From: Scala, Mary Joy
Sent: Thursday, October 27, 2016 2:06 PM
To: Julia Ledger (julia@dinsmorehouse.com)
Cc: Dinsmore House Inn (info@dinsmorehouse.com)
Subject: BAR Action - 1211 W Main Street - October 18, 2016

RE: Certificate of Appropriateness Application

1211 West Main Street (Dinsmore House Inn)

Final Details: Removal and Replacement of Side Porch, Streetscape and Yard Renovations

Elevations

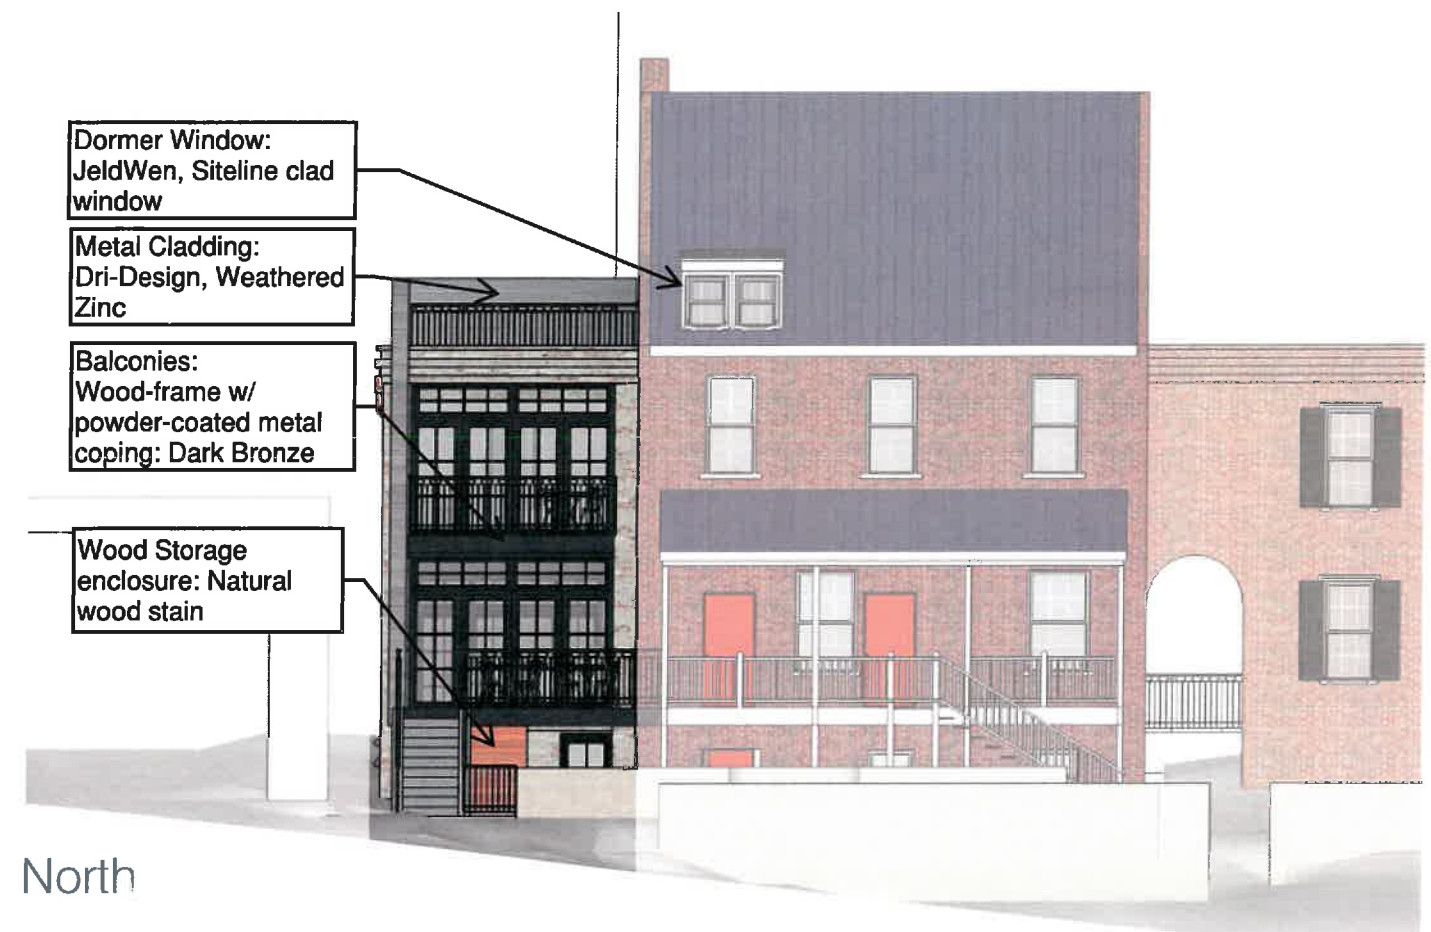
Staff has requested from the applicant a list of all approved material, colors, and specifications (storefront windows, fire-rated windows, clear glass, railings, brick, zinc).

The proposed materials of the rooftop structure should be clarified.

The dormer material should be noted.

The paint color for the rear porch should be noted.

The BAR should confirm whether the brick color is approved.

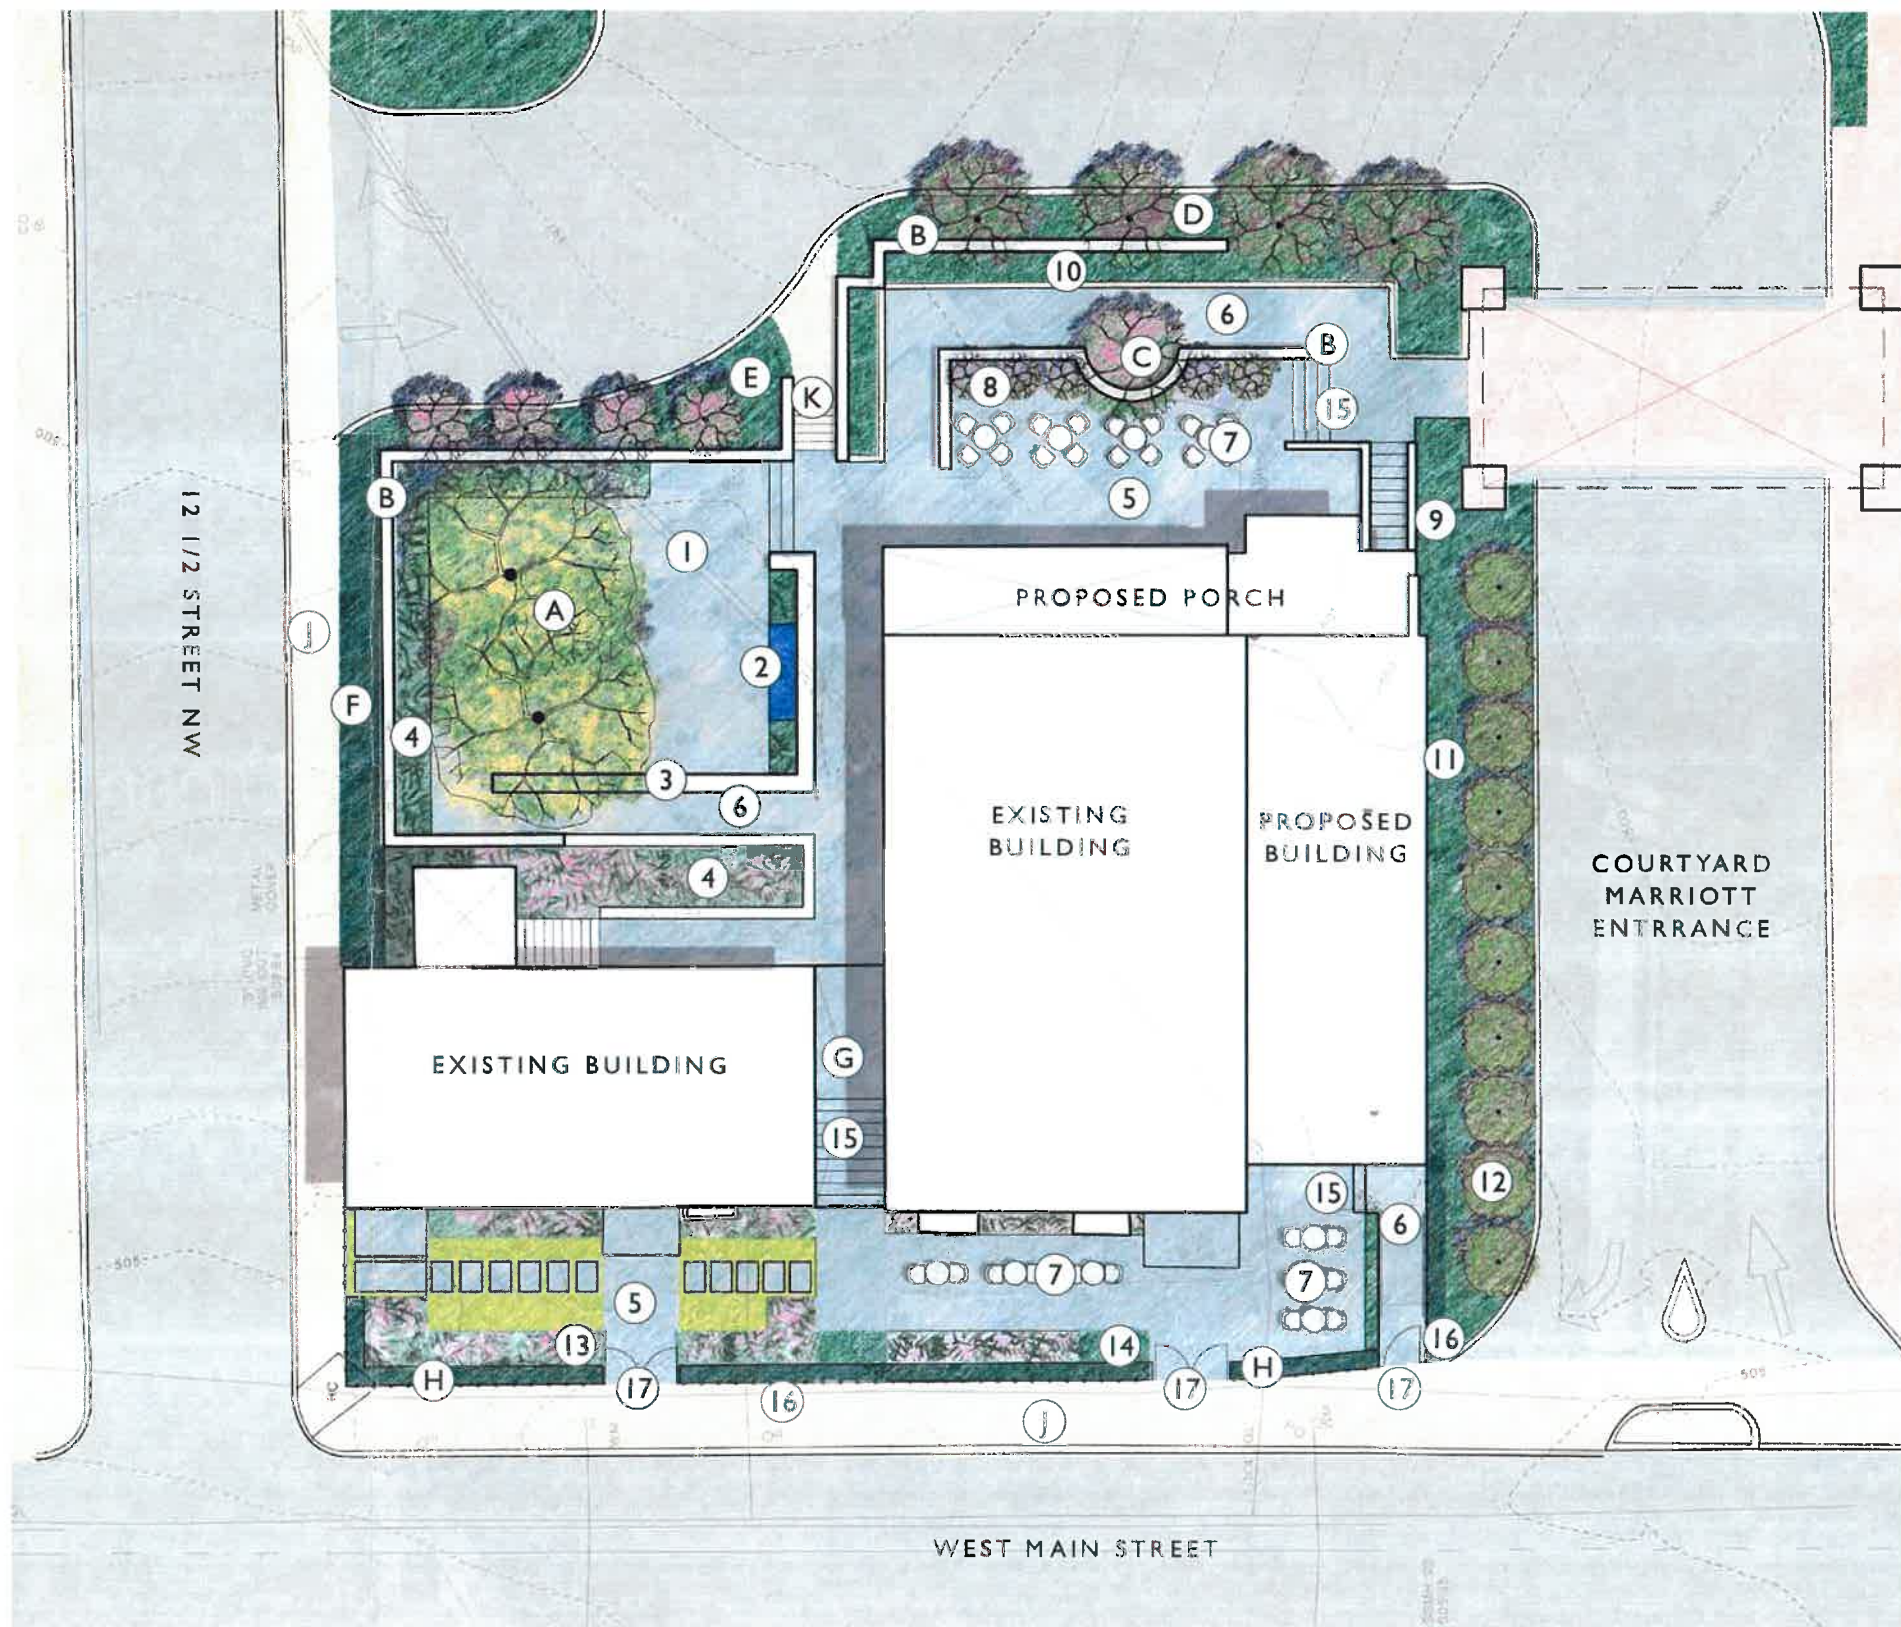
The hedge return needs to be shown.

- a painted balcony on the original building on the back (instead of stained or natural),
This needs to be noted.
- the return of the hedge in front of the addition behind the wrought iron fence,
The hedge has not been returned; a planter is shown.
